**TSG-RAN Meeting #26**  
**Athen, Greece, 08-10 December 2004**

**RP-040486**  
**Agenda item 7.3.2**

**Source: TSG-RAN WG2.**  
**Title: CRs on TR 25.309 (on Enhanced Uplink)**

**Title:** ⌘ Inclusion of e.g. physical layer model, MAC architecture, detail Node B scheduler mechanism and QoS Control principles

**Figure 7.2.1-1: UE side MAC architecture**

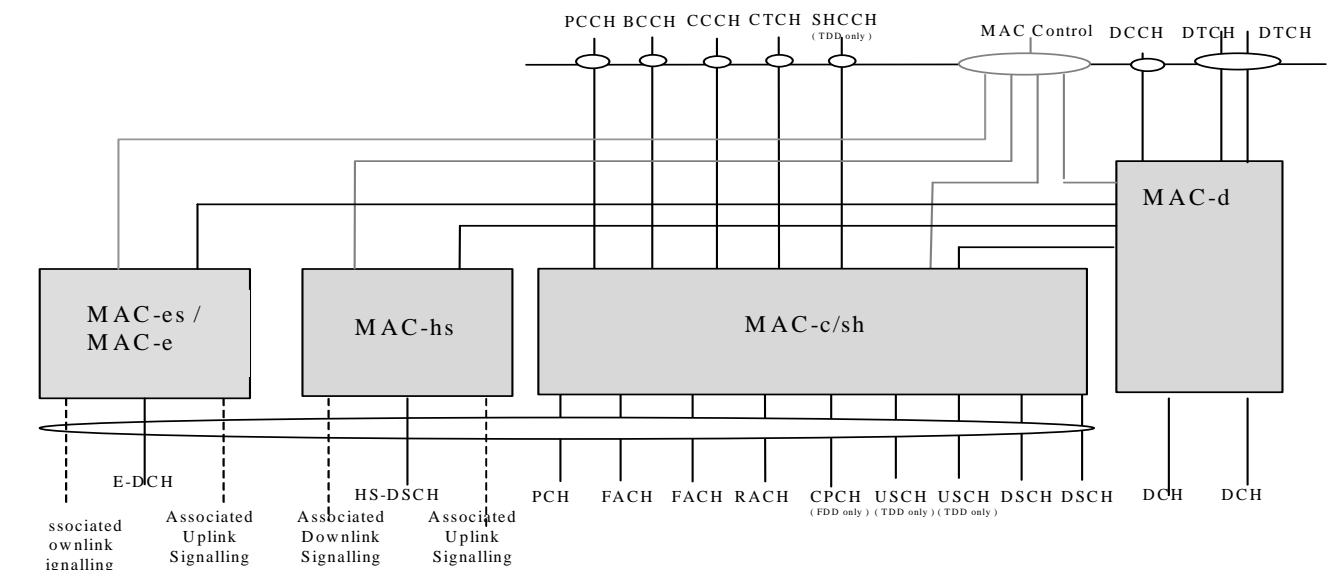
- Section 7.2.1:
  - Addition of the DDI, N and TSN field sizes.
  - Clarification of the special value of the DDI field (it indicates that no more data is contained in the remaining part of the MAC-e PDU). Figure 7.2.1-1 updated.

Figure 7.2.1-2: Simplified architecture showing MAC inter-working in UE. The left part shows the functional split while the right part shows PDU construction.

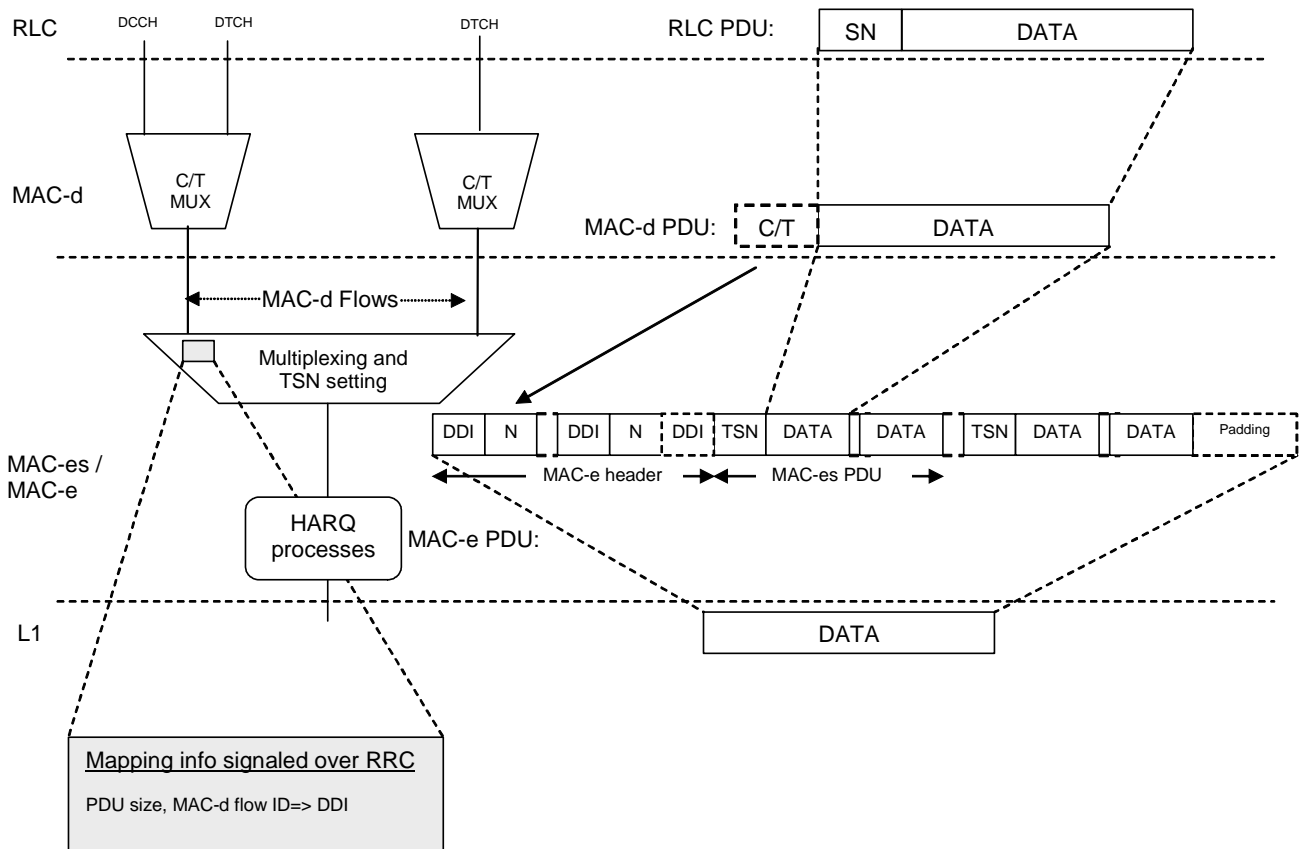
- Section 7.1.2: Inclusion of the fact that there is a one to one mapping between logical channel and reordering queue.
- Section 7.2.1: Update of the figure showing the simplified architecture showing MAC inter-working in UE.

- Section 7.2.1:
    - Addition of a Note on the possibility to bypass the C/T multiplexing box;
    - Correction to Figure 7.2.1-2 to clarify that setting of TSN is done at the same time than multiplexing;

**Figure 7.2.2-1: UE side MAC architecture/ MAC-d details**

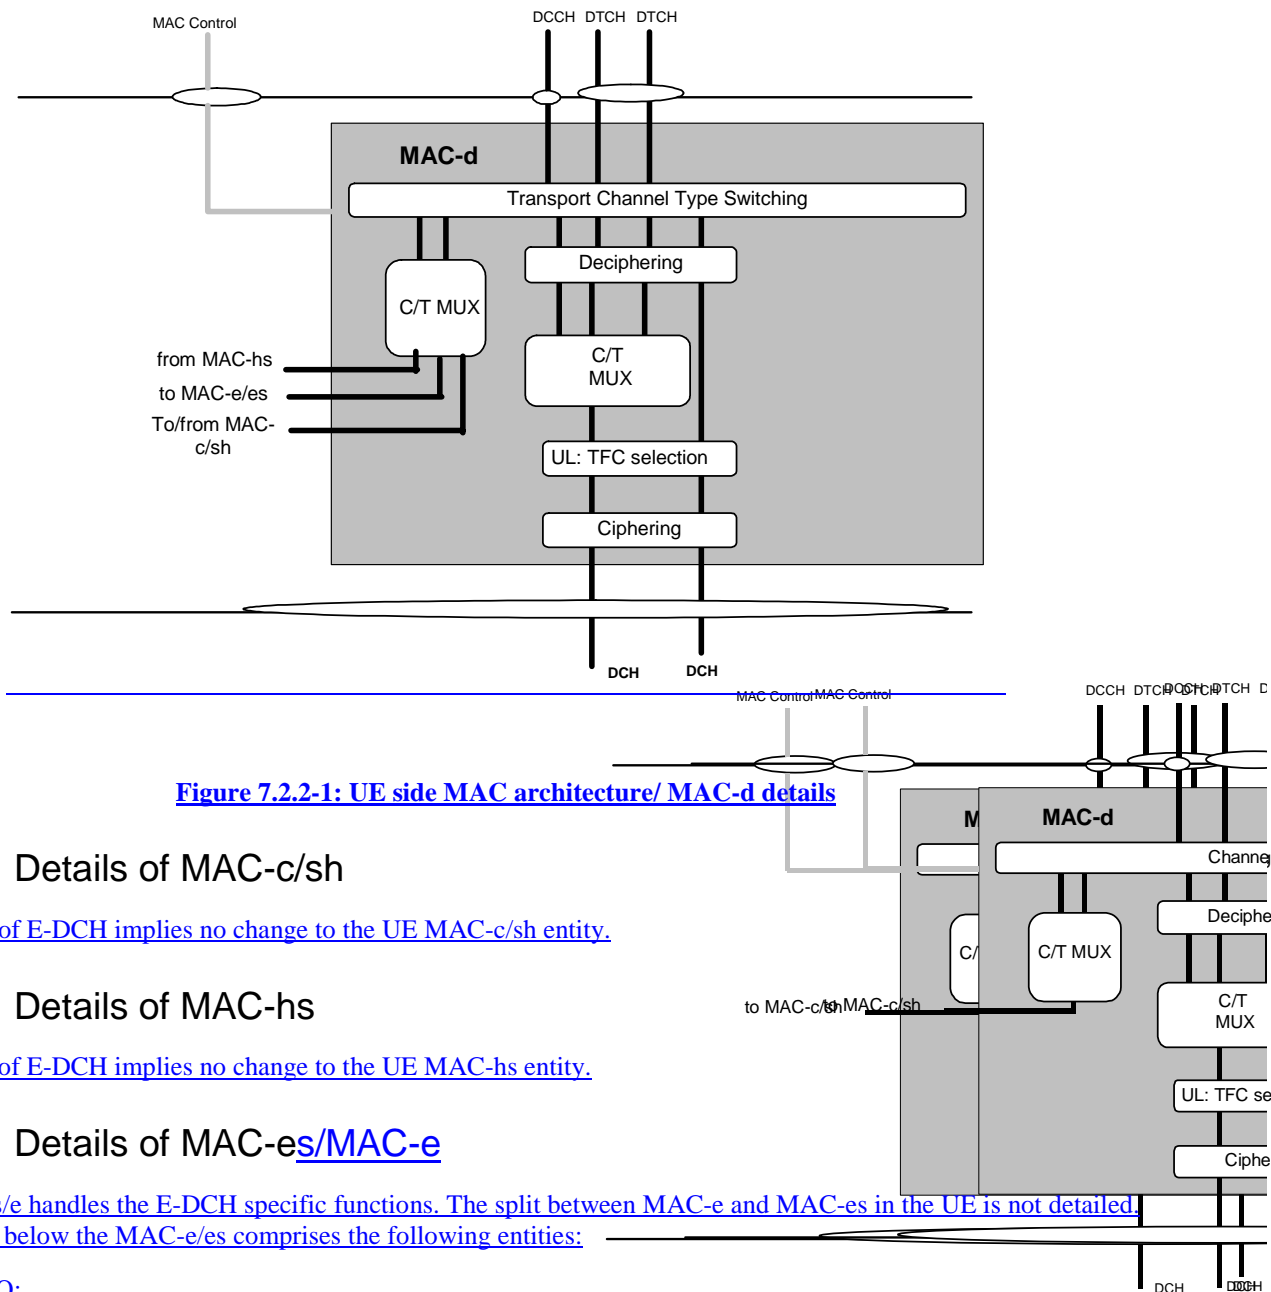
- Further text clarification on ACK/NACK combining.
- Section 7.2.1:
  - Further clarification regarding to the MAC-d Flow ID.
- Section 7.2.2:
  - Correction of the title of the Figure.

**Figure 7.2.5-1: UE side MAC architecture / MAC-es/e details**

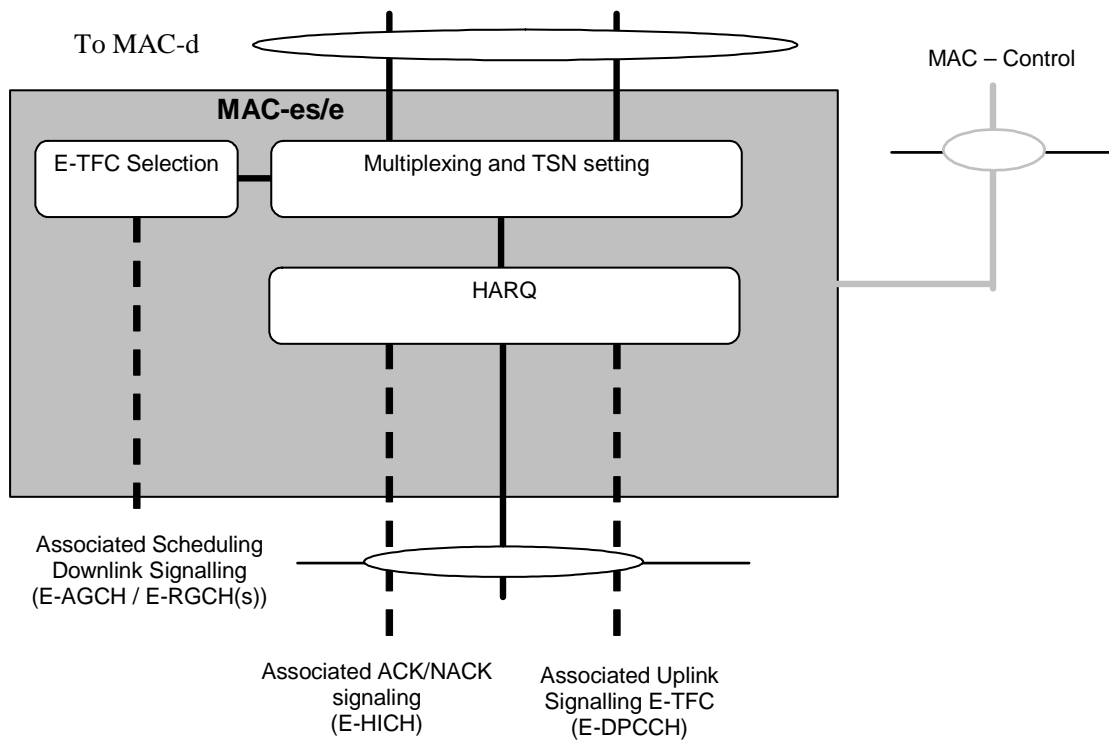
- Small rewording;
  - Section 6.3.2:
    - Small text correction in the last paragraphe;
  - Section 7.2.5:
    - Correction to Figure 7.2.5-1 to clarify that setting of TSN is done at the same time than multiplexing;

**Figure 7.3.1-2: Simplified architecture showing MAC inter-working in UTRAN. The left part shows the functional split while the right part shows PDU decomposition.**

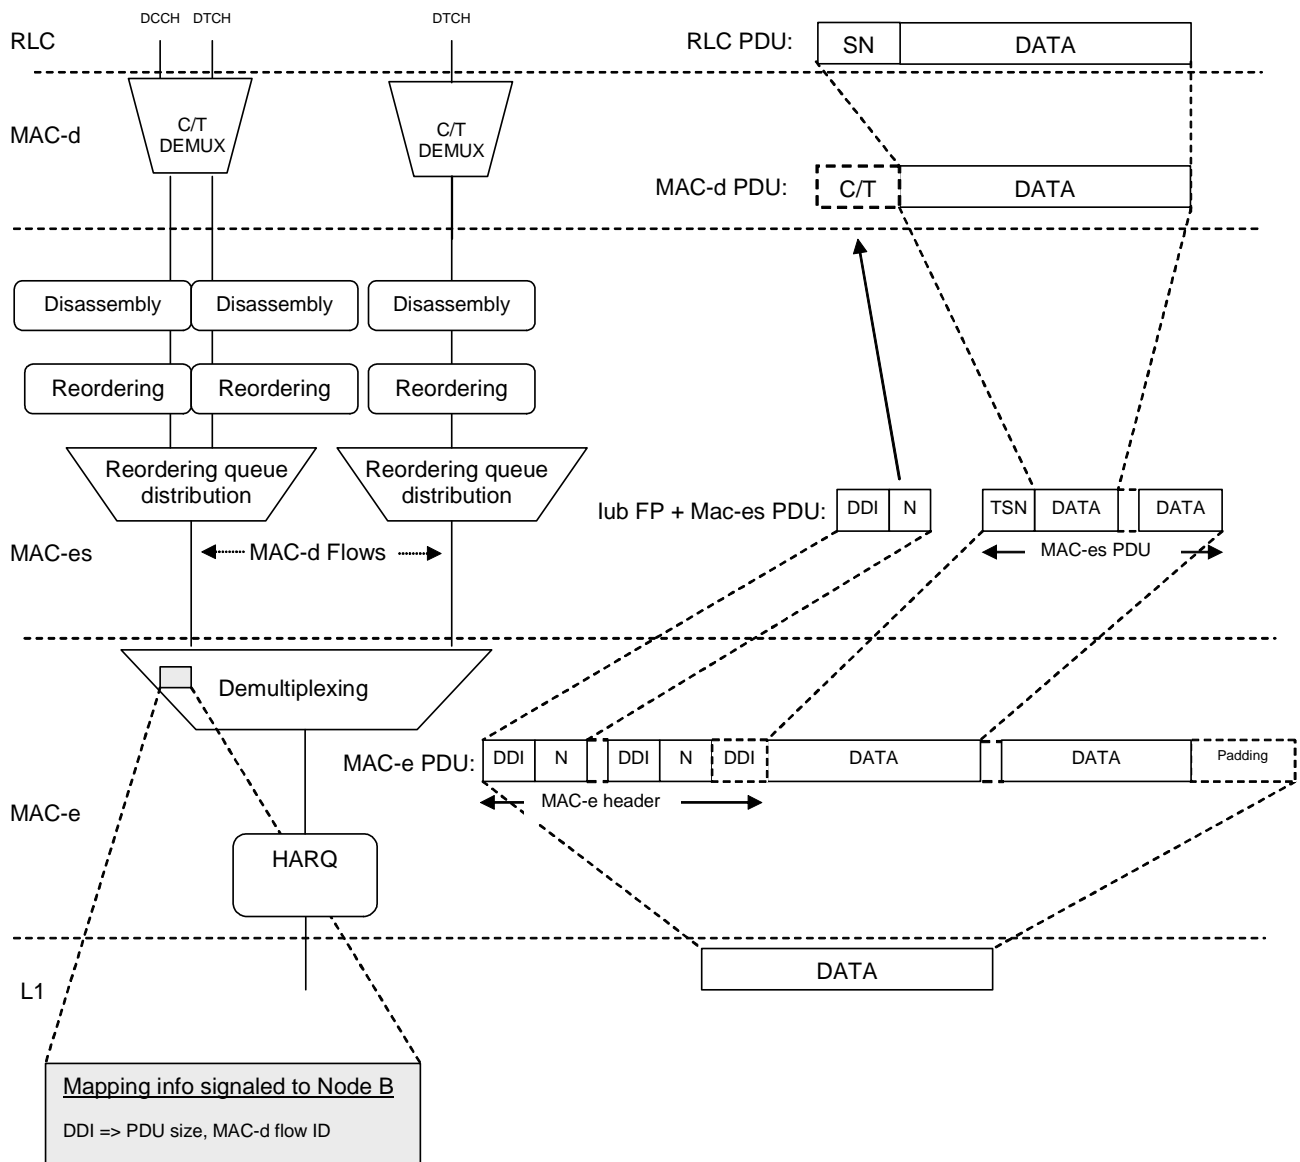
- Section 7.2.2: Inclusion of the fact that the support of E-DCH a new connection to MAC-es is added.
- Section 7.3.1: Update of the figure showing the simplified architecture showing MAC inter-working in UTRAN.

- Addition of the DDI size.
  - Clarification of the special value of the DDI field (it indicates that no more data is contained in the remaining part of the MAC-e PDU). Figure 7.3.1-2 updated.
